# Access Compliance Report

## Public Rights-of-Way (Curb Ramps)

Intersection ID: 54221	Main Street: MIDWAY_PARK_DR	Cross Street: NORTH_REA_PARK_LN	Location: SE
ADA ID: 0571A9D59AEB	Ramp Type: Directional1	Initial Pass/Fail: Fail	Overall Compliance: No
		Severity Score: 1.25

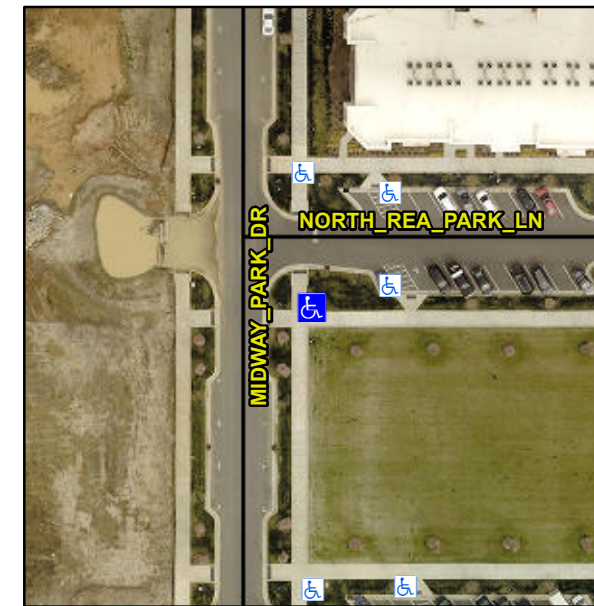
**R304.5.3**

Compliance	Description	Data	Compliance	Description	Data
N/A	Ramp Length (in)	94.0	N/A	Grade Break?	N/A
Yes	Ramp Width (in)	91.5	N/A	Grade Break Slope (%)	0.0
Yes	Ramp Slope (%)	6.0	N/A	Grade Break XSlope (%)	0.0
No	Ramp XSlope (%)	2.4			
N/A	Flare Type LT	N/A	N/A	Flare Type RT	N/A
N/A	Flare Slope LT (%)	N/A	N/A	Flare Slope RT (%)	0.0
N/A	Flare Traversable LT?	N/A	N/A	Flare Traversable RT?	N/A
N/A	Landing Length (in)	0.0	N/A	DWS Provided?	N/A
N/A	Landing Width (in)	0.0	N/A	DWS Contrast?	N/A
N/A	Landing Slope (%)	0.0	N/A	DWS Length (in)	N/A
N/A	Landing X Slope (%)	0.0	N/A	DWS Full Width?	N/A
N/A	Landing Curb? (Y/N)	N/A	N/A	DWS Offset LT (in)	N/A
N/A	Shared Landing?	N/A	N/A	DWS Offset RT (in)	N/A
N/A	Gutter Ponding?	0.0	N/A	Gutter Slope (%)	N/A
N/A	Gutter Lip Ht (in)	0.0	N/A	Gutter X Slope (%)	N/A
N/A	Painted X Walk1?	No		Road Slope (%)	2.1
	X Walk 1 Direction	To N		Road X Slope (%)	2.1
	X Walk 1 Width (in)	N/A		Clear Space?	N/A

**Remove & Replace Entire Ramp.**
